UW 19th Ave, LLC

4726 + 4730 19th Avenue NE Seattle, WA

RECOMMENDATION MEETING
FEBRUARY 10, 2020
PROJECT #3034062-LU

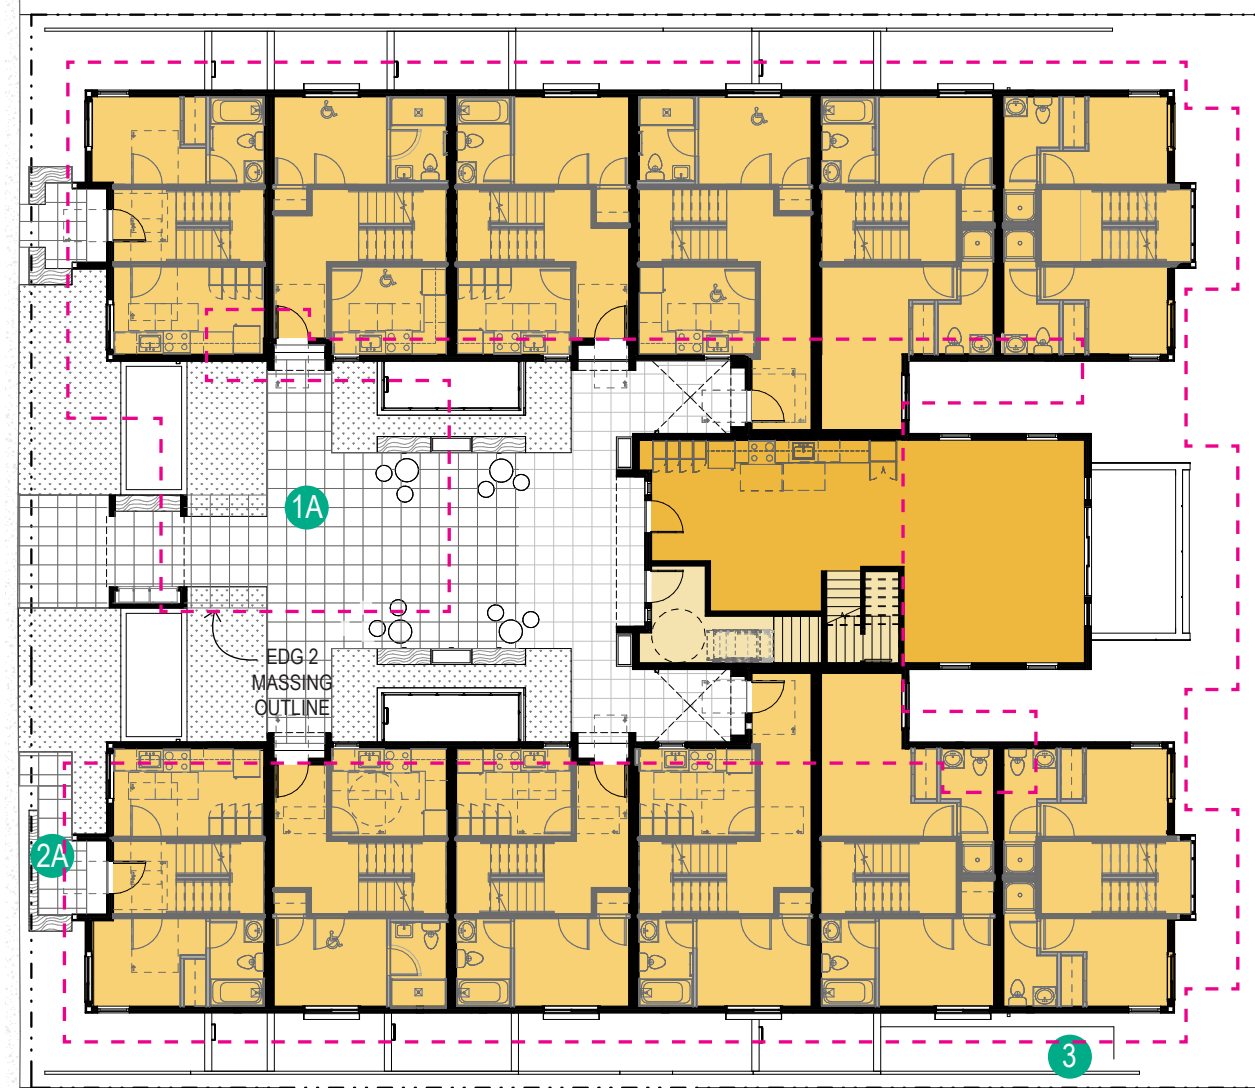
4A The Board stated that the proposed landscape plan feels too formal, especially given that college students are the anticipated residents of the project. Design the landscape plan with expected users in mind, creating an "outdoor common room" that facilitates activities relevant to student life. (DC3)

4B The Board recommended providing paved pedestrian paths across the planting strips on both 19th and 20th Avenues NE, to protect plant material from foot traffic. (DC3-C-3)

RESPONSE: The courtyard was opened up with more paved area to create an outdoor space that is more flexible for variety of event types for residents. Open space in front of the L2 amenity now allows for a variety activities to spill out to the courtyard including individual and group seating and recreations.

RESPONSE: Paved pedestrian paths were added along 19th and 20th Ave NE as recommended.

RECOMMENDATION PROPOSAL - LEVEL 2 PLAN

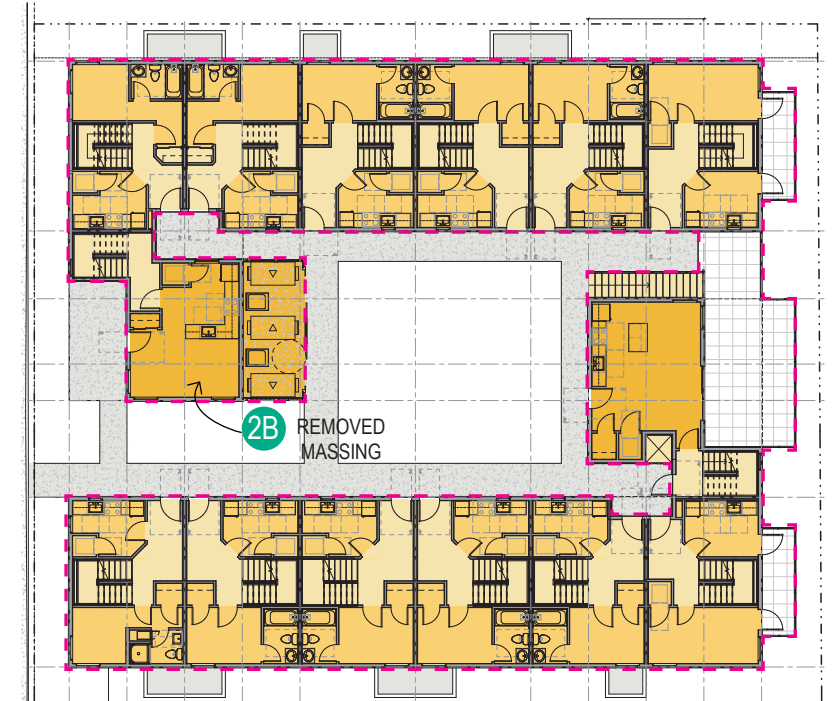
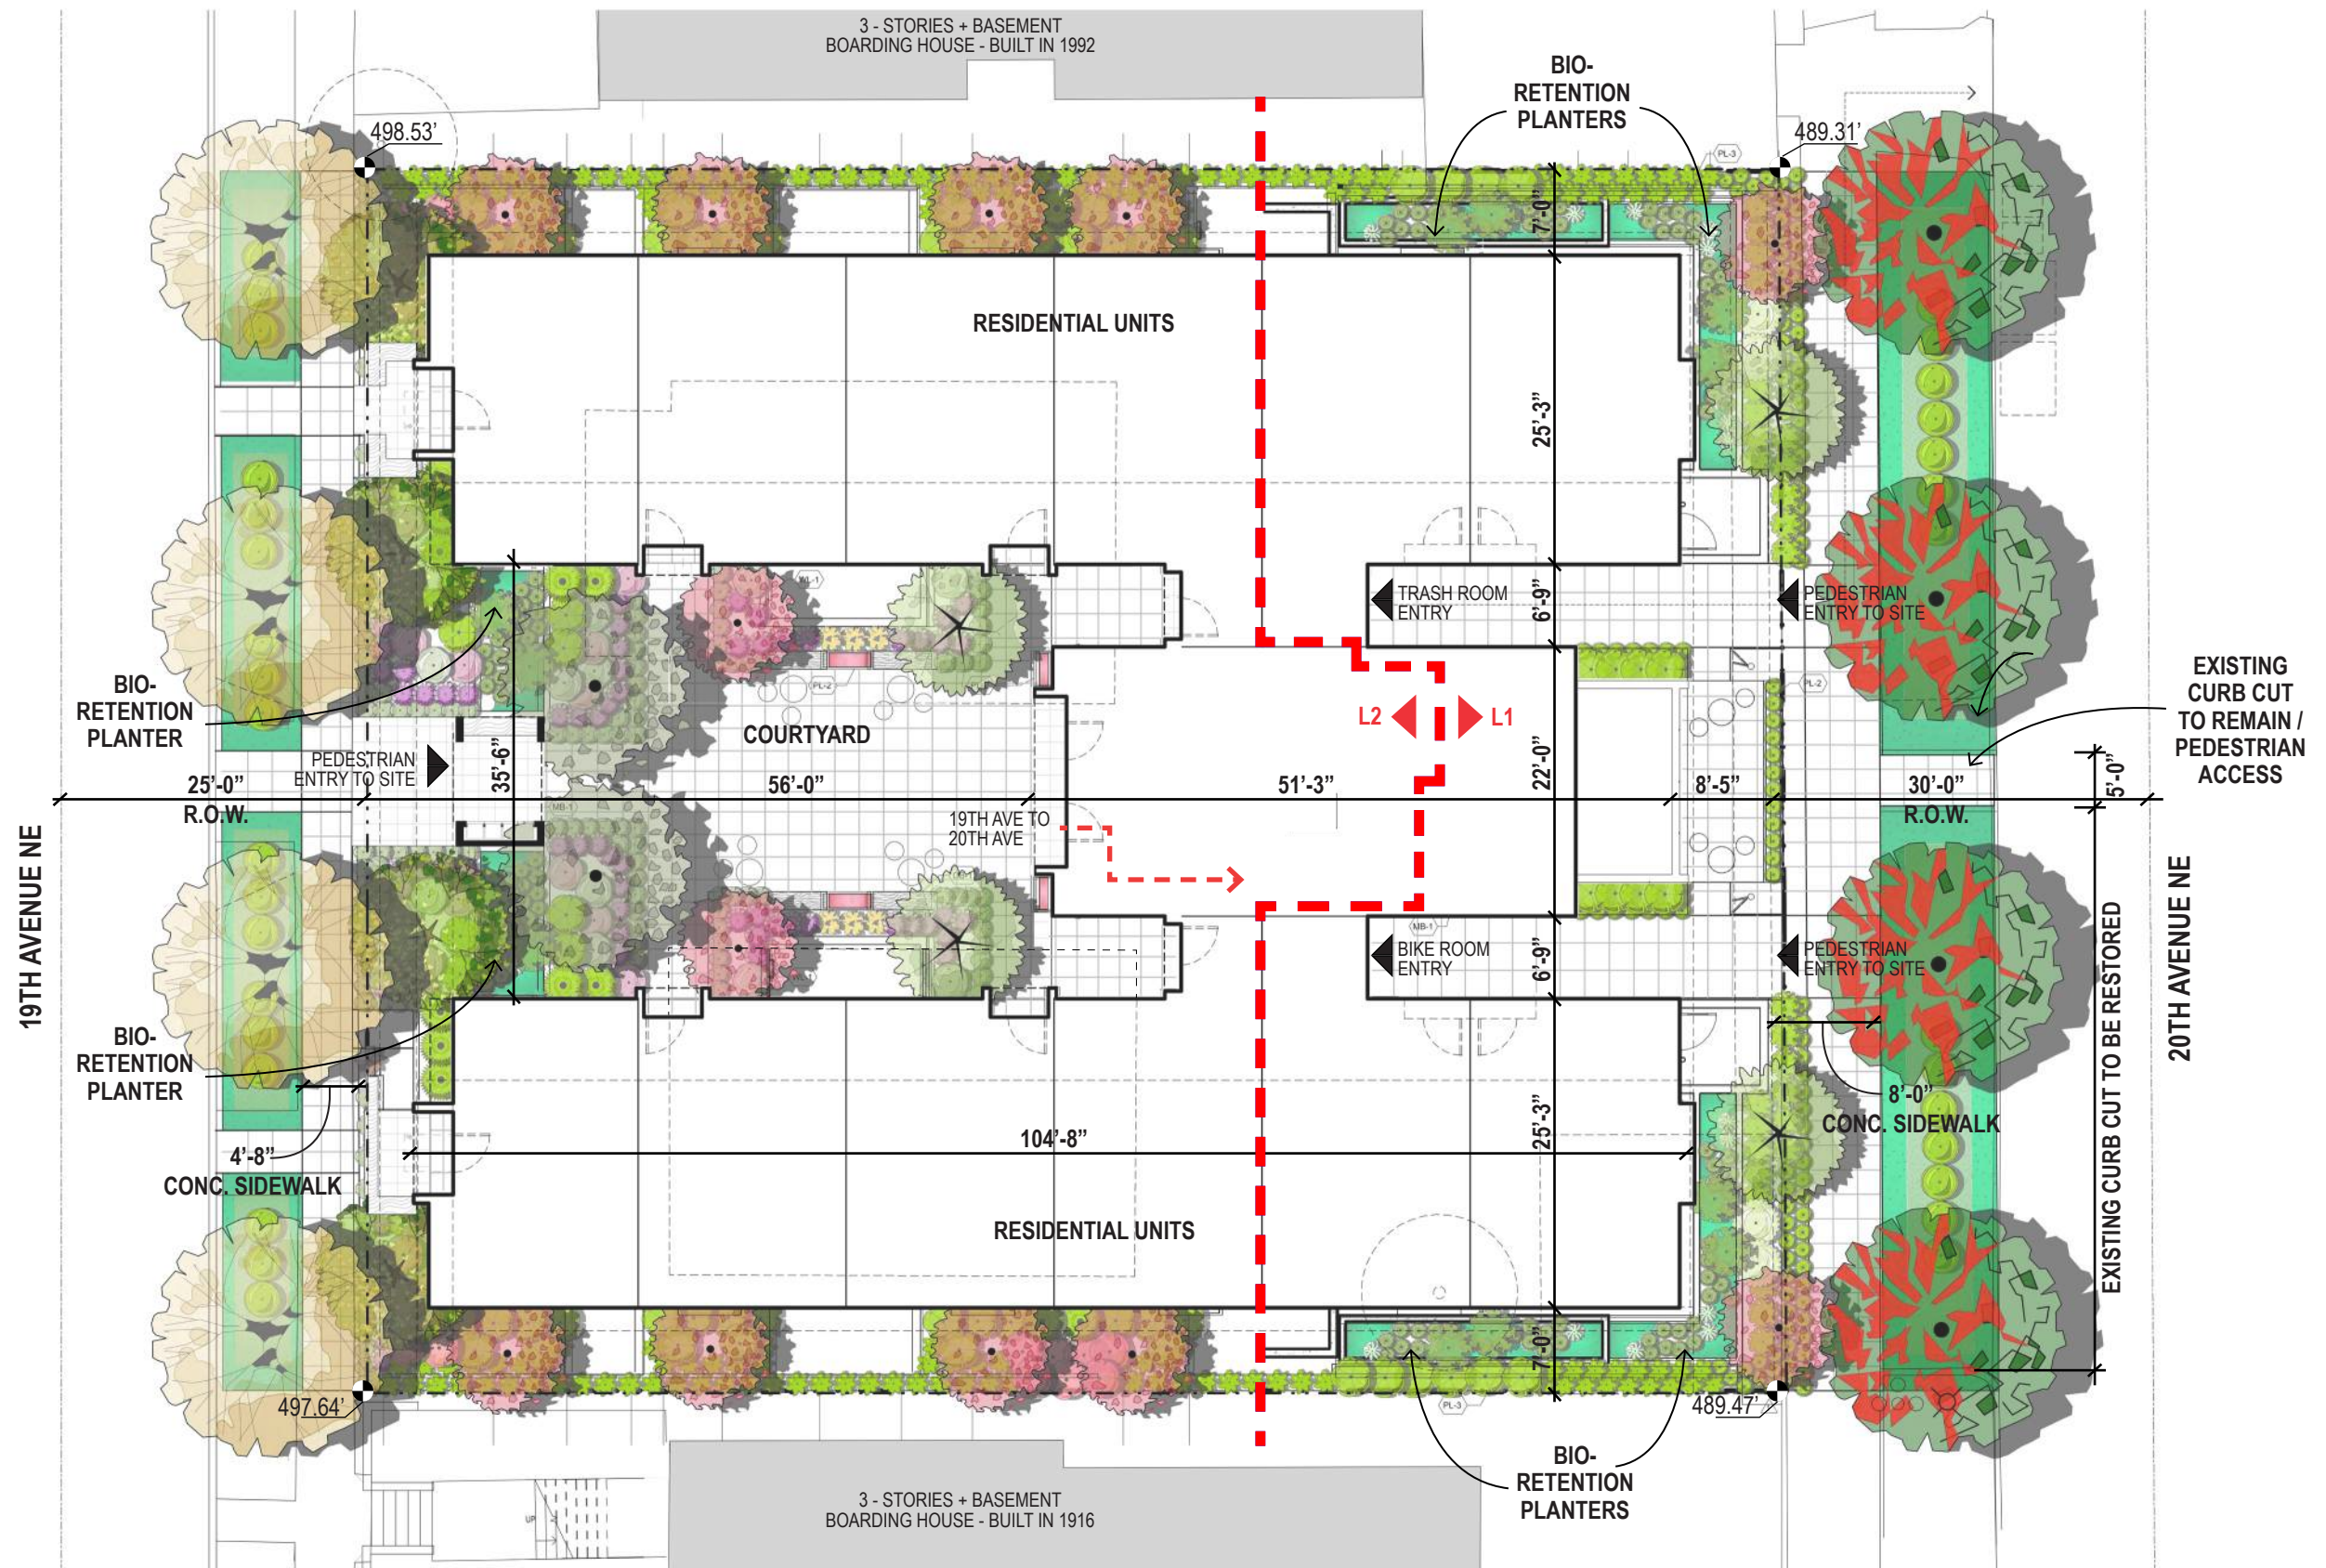
1A The Board supported further development of Option D, which orients units around a large central courtyard. The Board stated that the success of this concept will require eliminating or significantly reducing the central unit facing 19th Avenue NE, allowing for broad visibility into the courtyard from the public right of way. (CS2-B-3, DC2-A-1)

2A The Board stated that the two units facing 19th Avenue NE need to better engage the public realm. Orient entries for these two units to the street and consider additional methods of activating this façade. (CS2-B-2)

2B The Board noted that the elimination or reduction of the center unit facing 19th Avenue NE will increase the prominence of the center unit on the east side of the site. This unit should be designed as an intentional focal point, using quality materials and an attractive architectural concept. (DC2-B-1, DC4-I-i)

2C The Board supported the raised patios along the 20th Avenue NE frontage but noted that the proposed green screen was not an effective method of addressing the blank walls. Study alternative treatments for these blank walls, including the possibility of adding living space beneath the patios with glazing. (DC2-B-2)

RESPONSE: The massing of the proposed design has developed further from Option D massing option. The courtyard extends out to West by eliminating 19th Avenue facing unit massing per the Design review board's recommendation. To accommodate the visibility of courtyard, the courtyard opens up to be visible from the 19th Avenue, and a lower patio from Amenity space is also facing 20th Avenue to have visual connection to the street.

RESPONSE: 19th Avenue facing unit entries are reoriented towards 19th Avenue to engage with the public space. The middle unit facing 19th Avenue from EDG meeting 2 massing option D was removed to open up the courtyard for better visibility and to activate the courtyard for variety of events for residents. Entry portal with address signage was added along 19th Avenue and an address signage on a railing at the raised deck along 20th Avenue for better wayfinding from the sidewalk on both 19th and 20th Avenue. Each unit entry has similar entry portal detailing to emphasize each unit entries as well.

RESPONSE: The center unit facing 19th Avenue was eliminated to increase the courtyard area. The entry portal on the middle unit was added to emphasize the center unit, and the program of the center unit was changed to amenity rooms on Level 1 and 2 to serve as a focal point programmatically. Instead of introducing new materials, the siding color/material at recessed area (adjacent to the middle units) has neutral color to accentuate the middle unit. Also, taller windows at middle unit were placed to increase the prominence of the center unit.

RESPONSE: The green screens along 20th Avenue were eliminated, by lowering units down to sidewalk grade along 20th Avenue. Patio spaces facing 20th Avenue were added to engage the streetscape. The center unit amenity space on 20th Avenue was pulled away from the East property line to create an open space as patio at grade to complement the deck above.

D1 L2 PLAN - FACADE LENGTH

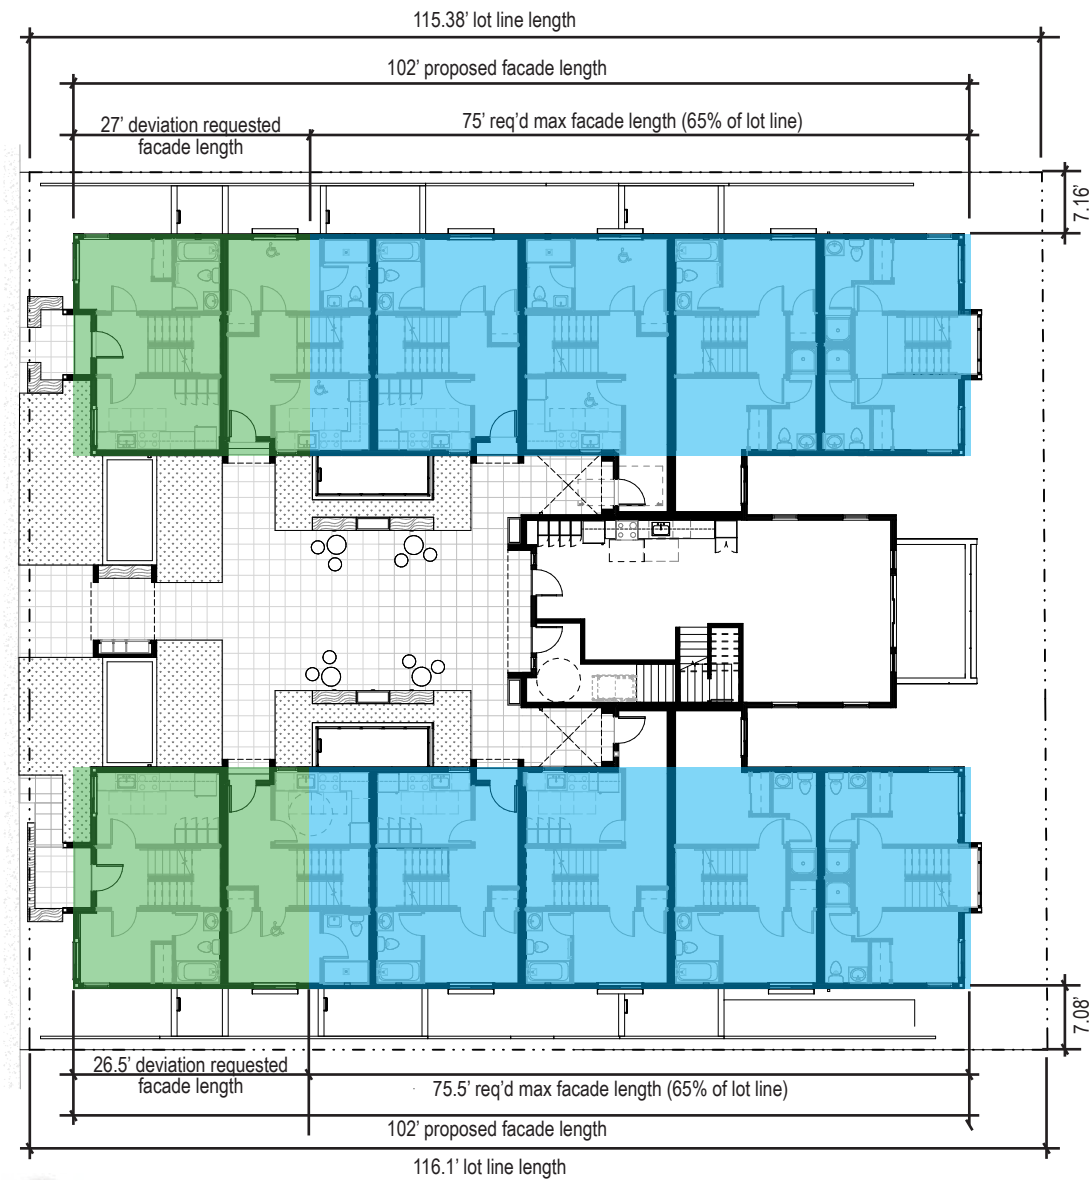
DEPARTURE NUMBER	LAND USE CODE SECTION	ITEM	CODE REQUIREMENT	DEPARTURE REQUESTED	DESIGN RATIONALE
D1	SMC23.45.527.B.1	Max. Facade Length	The maximum combined length of all portions of façades within 15 feet of a lot line that is neither a rear lot line nor a street or alley lot line shall not exceed 65 percent of the length of that lot line.	Allowed structure width is 65% of the lot line, which is 75', and project proposes 102' facade length on both side lot lines. 1.1: North facade length proposed = 102' (max 65% allowed, 23.4% increase in allowable facade length proposed) 1.1: South facade length proposed = 102' (max 65% allowed, 23.4% of increase in allowable facade length proposed)	Central courtyard concept allows creation of maximum amount of centralized open space for residents which is a common architectural feature within this area (PL-2). Main open space facing 19th Ave NE creates central point of community which reinforces street level interaction (PL-3) as well as utilizing an entry portal as a symbolic transition from public to private space. The central courtyard provides buffer space between individual unit entries and the sidewalk and the courtyard utilizes benches and low walls / planters as well as furniture for resident use and overhead "festival lighting" to maximize usability of the courtyard for all occupants (PL-3, DC-1, DC-3). An additional pair of open spaces both at grade and elevated above sidewalk along 20th Ave NE provide similar benefits for residents and supports visual connection and surveillance but separated enough to maintain privacy (PL-3).

D2 L2 PLAN - SETBACKS

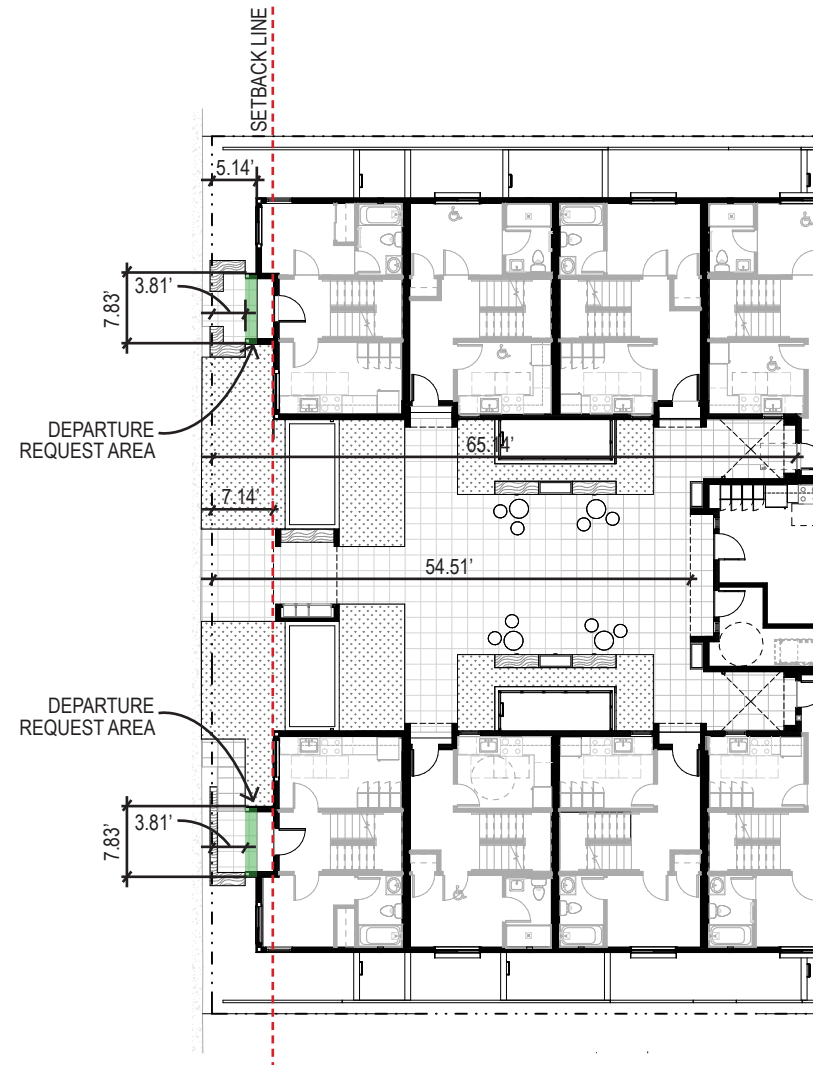
D2	SMC23.45.518.A	Setbacks and separations	The minimum required setback to be 5 feet and the average required setback to be 7 feet.	Project proposes 26.15' average setback on 19th avenue with 3' - 9 1/4" setback on 15' - 8" length of West facing facade (min 5' allowed).	Architectural feature of entry portal modulation requires minimal extension into front setback while still meeting the average setback on 19th Ave NE as a whole. Benches and landscaping flank these entryways creating individualized unit entry buffers (PL-3) while minimizing physical separation between sidewalk and unit. The portal engages the unit entry to the public realm as well as the streetscape.
